OFFICE OF THE COUNCIL
MEETING PACKET FOR THE
COMMITTEE OF THE WHOLE
NOVEMBER 19, 2025
6:00 P.M.

1. The subject matter of Petition 2025-07-02-15, submitted by Mannik & Smith Group, on behalf of Clean Express Car Wash, requesting waiver use approval to operate an Auto-Wash Establishment, at 38888 Six Mile Road, located at the N.E. corner of Fox Drive and Six Mile Road in the S.W. ¼ of Section 7. (CR 340-25).

Plan Review for: **Clean Express Car Wash**
38888 6-Mile Rd, Livonia MI
Petition 2025-07-02-15

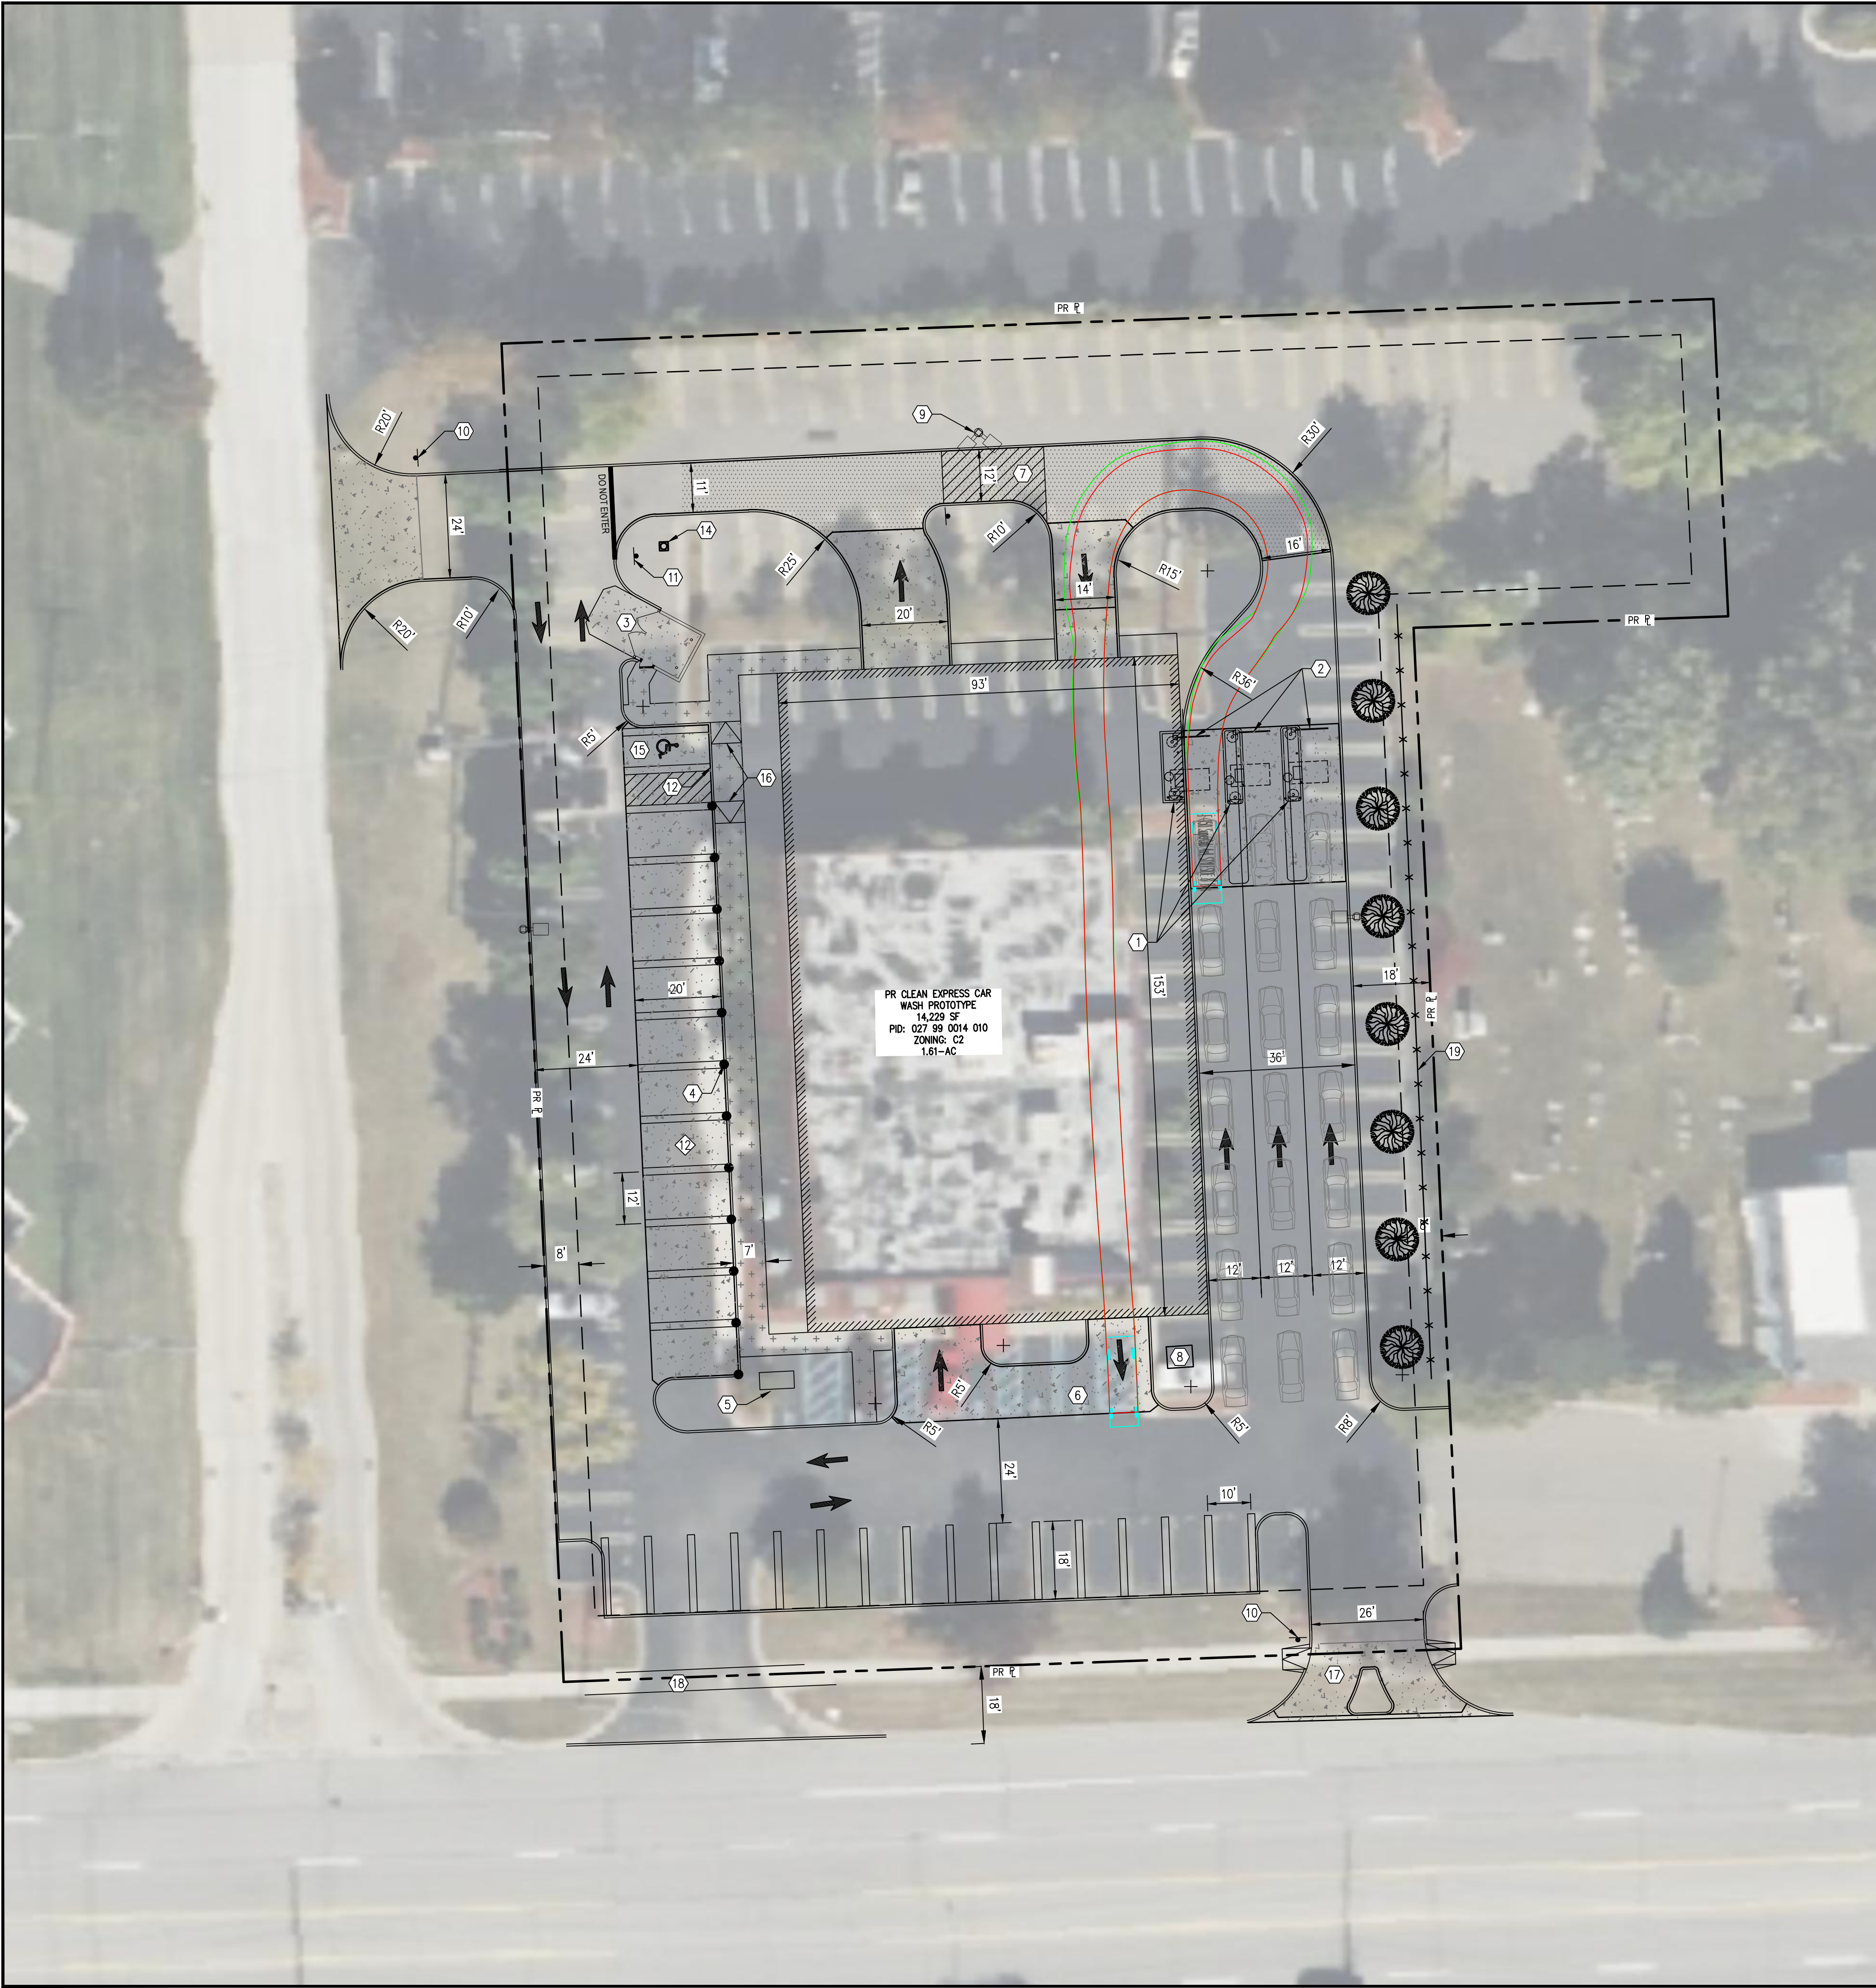
Please see the attached new data for the Clean Express carwash petition, including revised building elevations showing additional glazing on the south façade, and brick roll locks along the top of the building and above the overhead doors on all four sides, and a revised site plan showing the setback of the stacking lanes from the cemetery increased from 10 feet to 18 feet.

Adjustments have also been made to the site plan to improve the shared property boundary with the cemetery and to the building's south elevation. Traffic representatives will be in attendance to answer questions about the study as well as how the future development of the area was taken into account.

SCALE: 3/16" = 1'-0" (U.N.O.)
SHEET # / DESCRIPTION
EXTERIOR ELEVATIONS
A2-1
DATE: 08.11.2025
PLANNING COMMISSION
SBA STUDIOS PROJECT # 2025-371

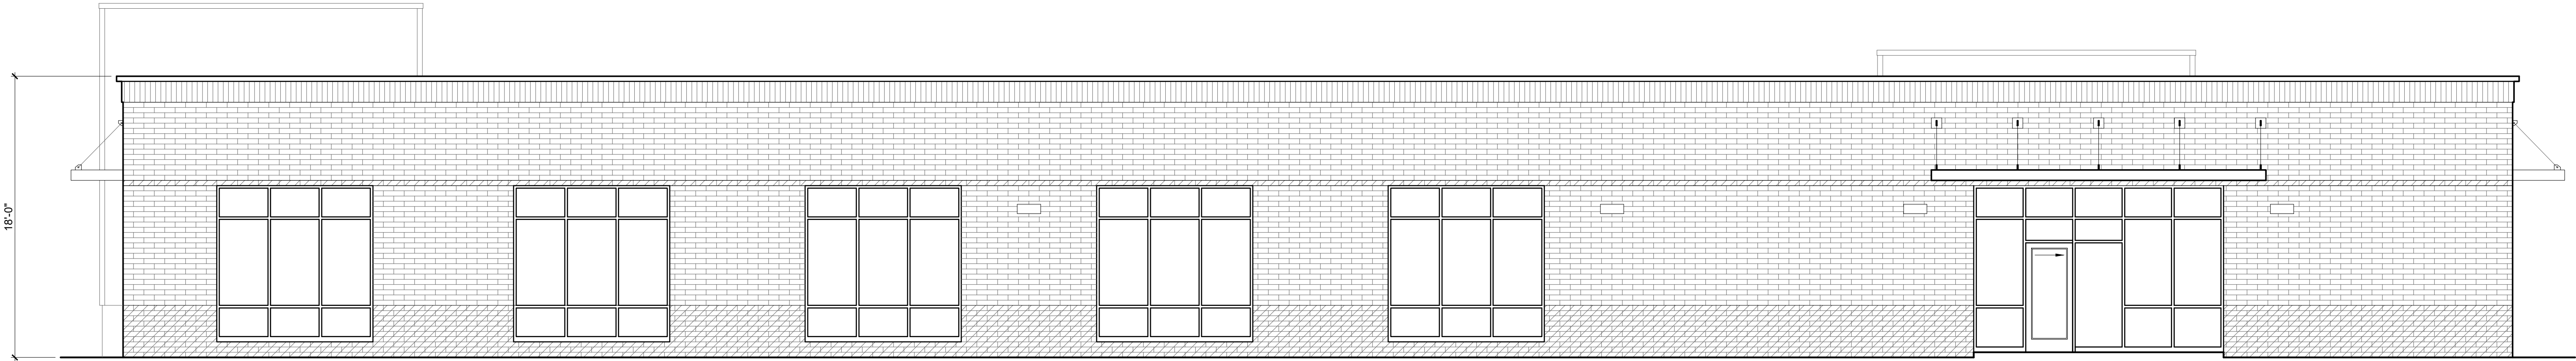
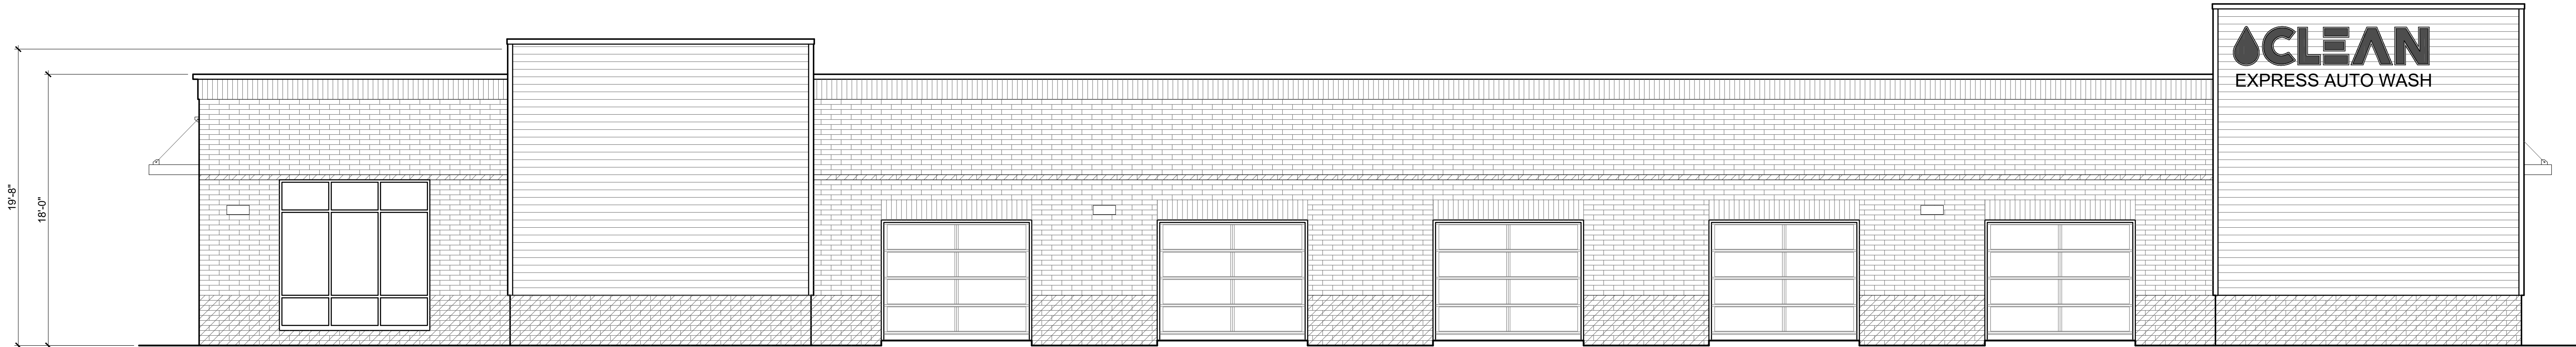
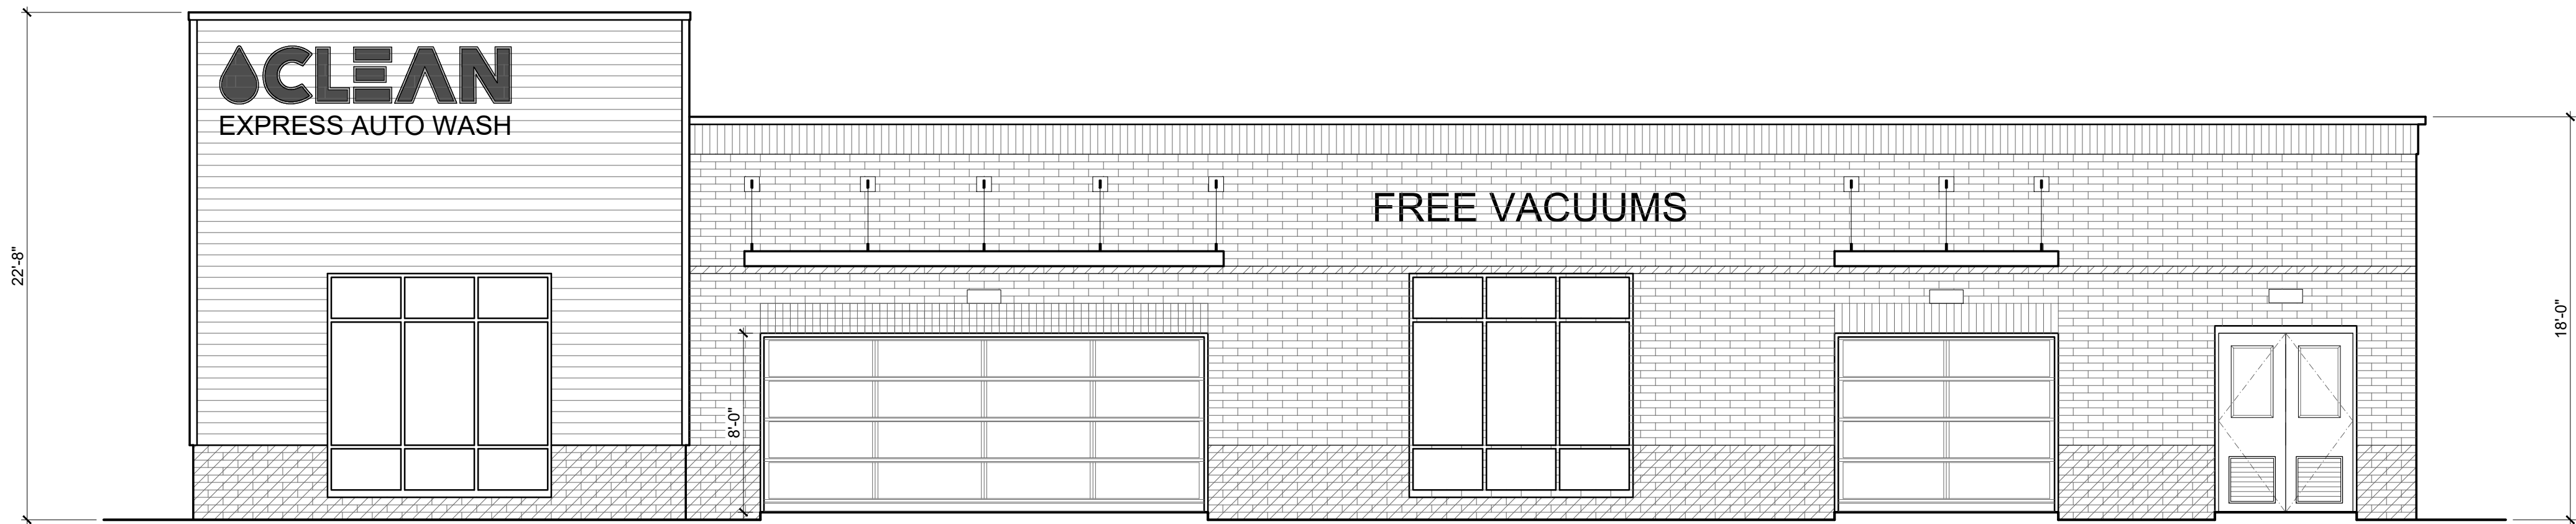
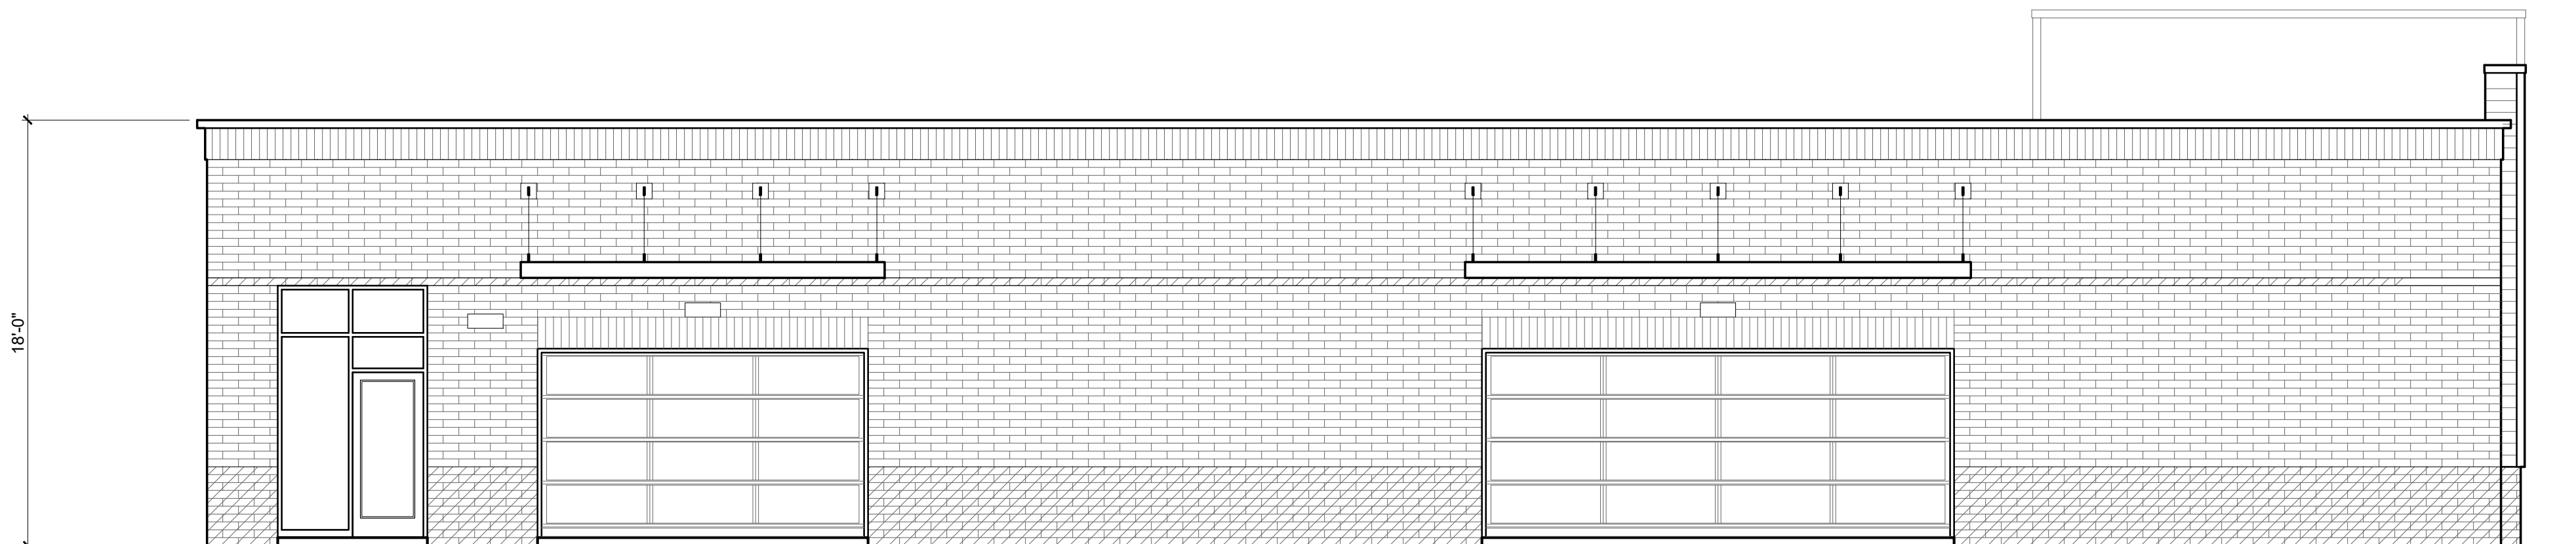
5. The Exterior Elevations Plan, identified as A2-1, dated July 10, 2025, prepared by SBA Studios, is approved and shall be adhered to except the south elevation, which shall be enhanced to the satisfaction of the Planning Director.
